SERVICE BULLETIN REVISION TRANSMITTAL SHEET

TITLE: AIR CONDITIONING - PRESSURE CONTROL AND MONITORING -

INTRODUCE MODIFIED PRESSURE CONTROLLER

This page transmits Revision No.01 of Service Bulletin No.A320-21-1189

Figure A-GBAAA - Sheet 01
Removal and Installation of the Modified Cabin Pressure Controller

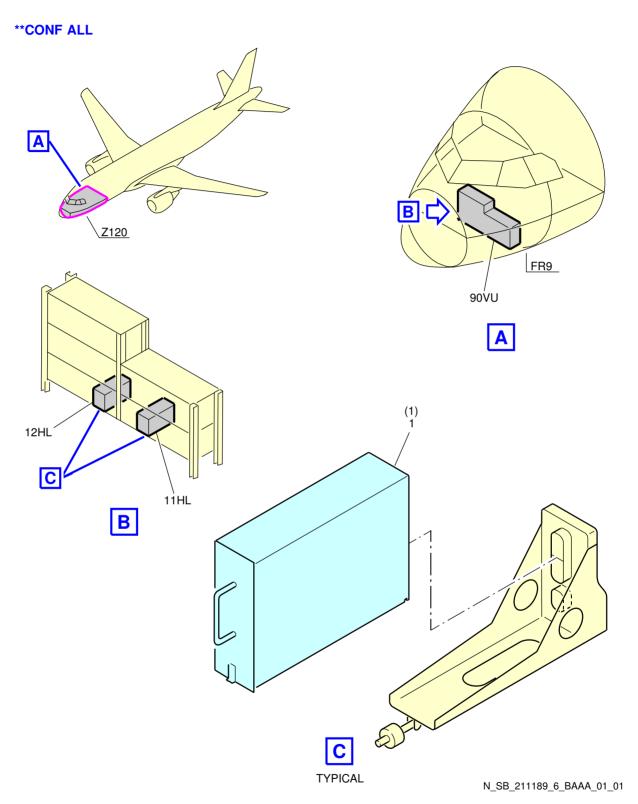
- (a) Remove the Cabin Pressure Controller (CPC), FIN 11HL and FIN 12HL
 - Remove the Cabin Pressure Controller (CPC), FIN 11HL and FIN 12HL (Refer to AMM Task 21-31-34-000-001).

Refer to Fig. A-GBAAA Sheet 01
